Model: AP-P2 3000 Sheet Finisher		Date: 31-Mar-10	No.: RB805001
Subject: Parts information		Prepared by: M. Kumagai	
From: 1st Overseas Tech Support Sec., 1st PQM Dept.			
Classification:	<input type="checkbox"/> Troubleshooting <input type="checkbox"/> Mechanical <input type="checkbox"/> Paper path <input type="checkbox"/> Product Safety	<input checked="" type="checkbox"/> Part information <input type="checkbox"/> Electrical <input type="checkbox"/> Transmit/receive <input type="checkbox"/> Other (     )	<input type="checkbox"/> Action required <input type="checkbox"/> Service manual revision <input type="checkbox"/> Retrofit information <input type="checkbox"/> Tier 2

## 11. Staple Tray 2 (B804/B805)

Model: AP-P2 3000 Sheet Finisher		Date: 25-May-10	No.: RB805002
Subject: Parts information		Prepared by: M. Kumagai	
From: 1st Overseas Tech Support Sec., 1st PQM Dept.			
Classification:	<input type="checkbox"/> Troubleshooting <input type="checkbox"/> Mechanical <input type="checkbox"/> Paper path <input type="checkbox"/> Product Safety	<input checked="" type="checkbox"/> Part information <input type="checkbox"/> Electrical <input type="checkbox"/> Transmit/receive <input type="c

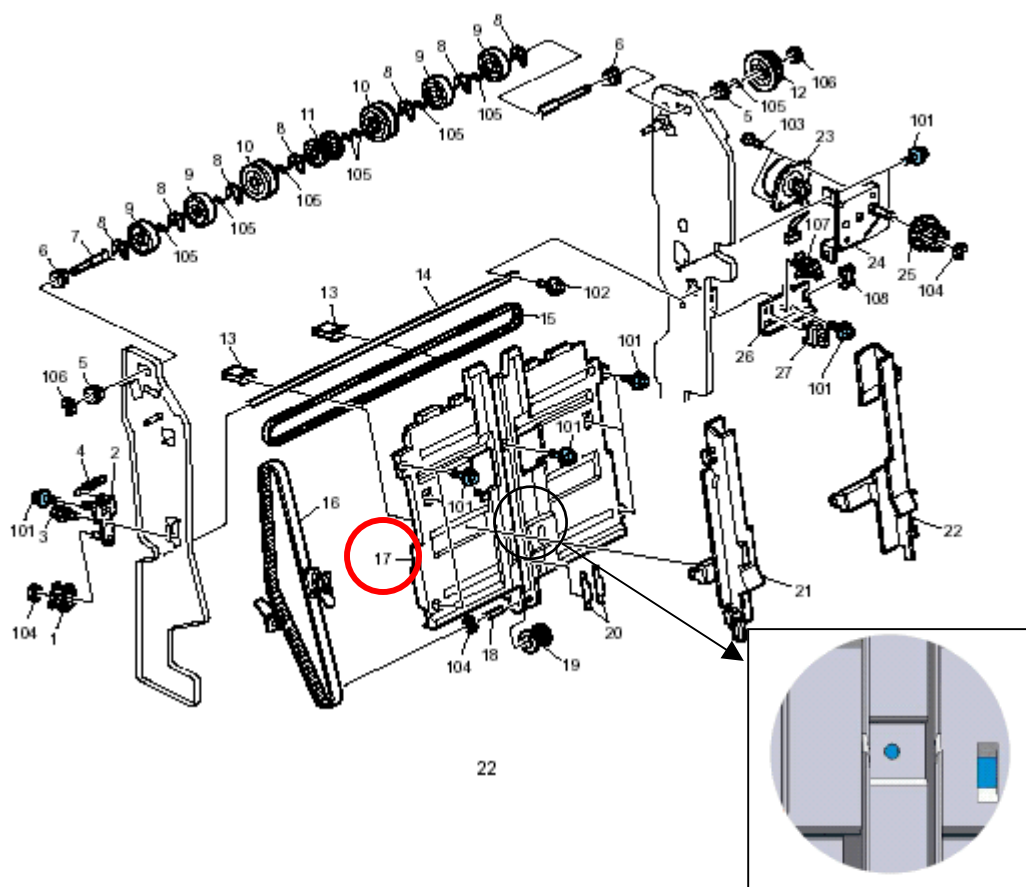
**Change:** A tapping screw was added for attaching the stapler tray to the lower stay positioning sensor, and screw holes were added as shown below.

**Reason:** To further improve structural reliability.

Old part number	New part number	Description	Q'ty	Int	Page	Index	Note
B7004180	D3734180	Stapler Tray	1-1	X/X	23	17	X/O as a set
B7004167	D3734167	Stay: Lower: Positioning Sensor	1-1	X/X	29 (B804) 25 (B805)	7	
-	04543006Q	Tapping Screw - M3x6	7-8	-	23	101

### 15.Staple Tray 6 (B804)

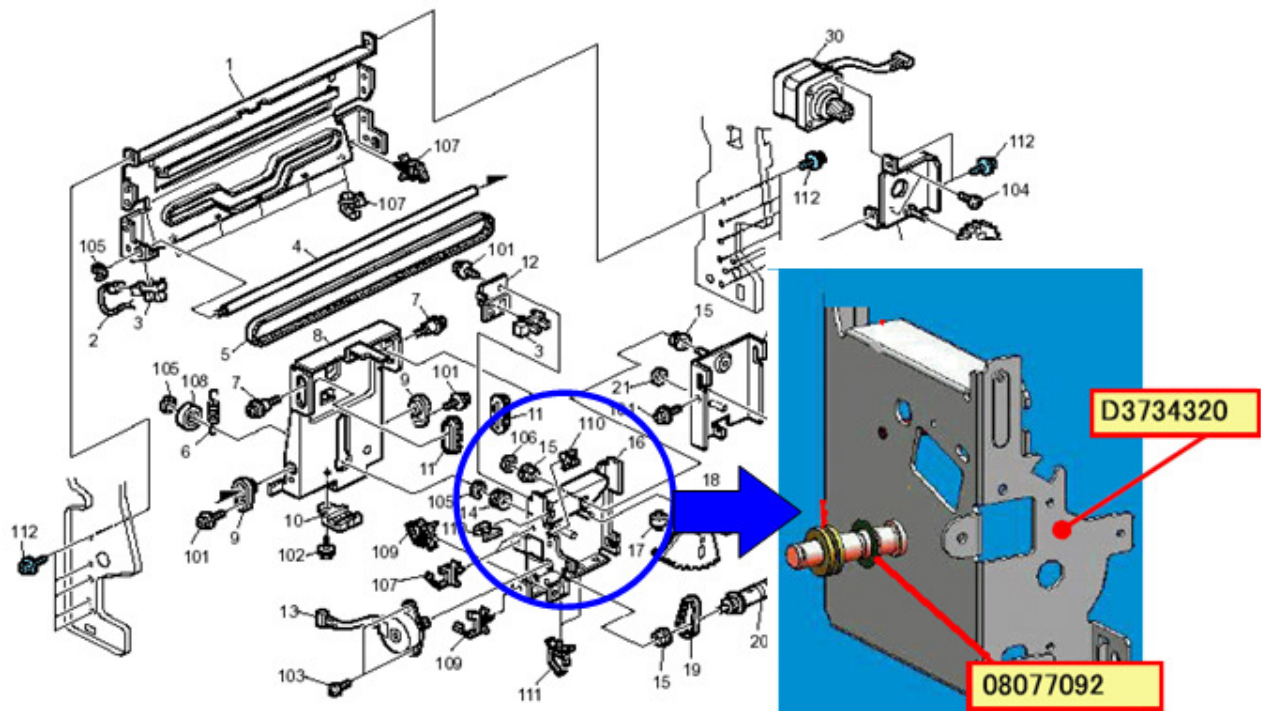
**Change:** A spacer was added to the shaft of the stapler bracket.

**Reason:** To improve the reliability of staple positioning.

Old part number	New part number	Description	Q'ty	Int	Page	Index	Note
B7004320	D3734320	BRACKET:STAPLER:SLIDE:ASS'Y	1	X/O	27	16	
	08077092	SPACER - 10.5/16	1		27	114*

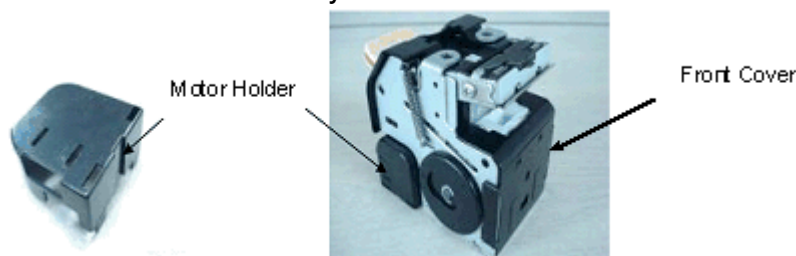
**Change/Reason:** The following parts were changed to apply for the new Model AT/AP-C2.5

Old part number	New part number	Description	Q'ty	Int	Page	Index	Note
B7003500	B8043510	STAY:UNIFORM:ASS'Y	1	X/O As a Set	15	27	
B7005304	B8045404	HARNESS:SURFACE OF PAPER SENSOR	1		15	31	
<b><i>B8045310</i></b>	<b><i>B8045410</i></b>	<b><i>HARNESS:STEPPER MOTOR</i></b>	<b><i>1</i></b>		<b><i>37</i></b>	<b><i>4</i></b>

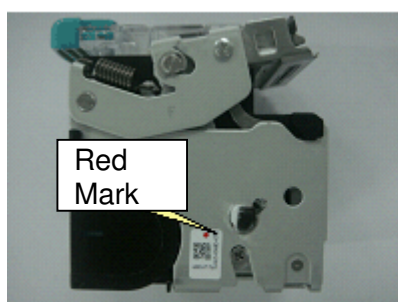
Some parts of the stapler unit (black resin parts shown below) contained PBDE material in excess of the limits set by the RoHS Directive.

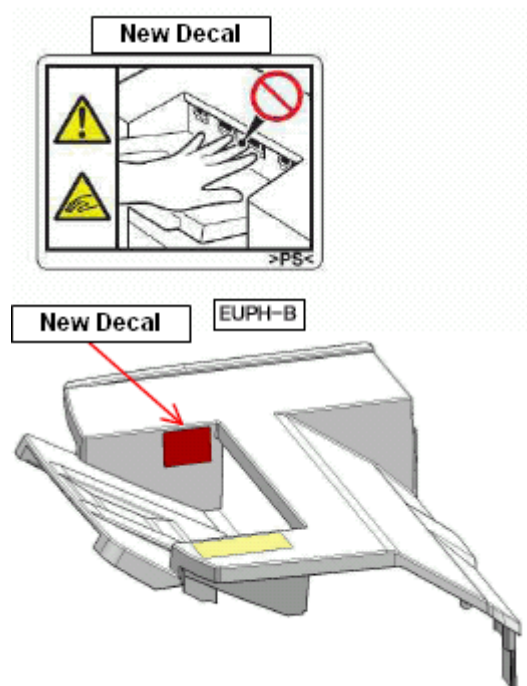
**Important:** Stapler units on some of these affected finishers have already been replaced with the normal ones. If there is a **red dot** on the stapler unit's label (see the photo below), you **do not need to replace** these units.

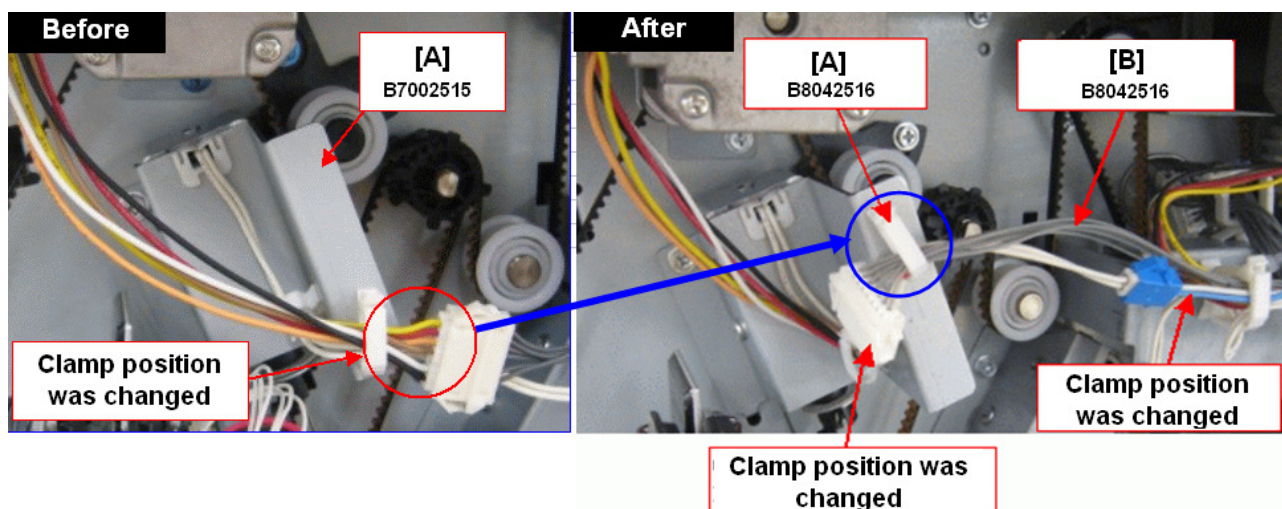
**Change / Reason:** The following clamp position [A] and harness length [B] were changed to improve product safety.

Old parts number	New parts number	Description	Q'ty	Int	Page	Index
B7002515	B8042516	BRACKET:DCSOL:GAT E PAWL:STAPLE	1	X/O As a Set	31	1
B8045410	B8045411	HARNESS:STEPPER MOTOR	1		37	4
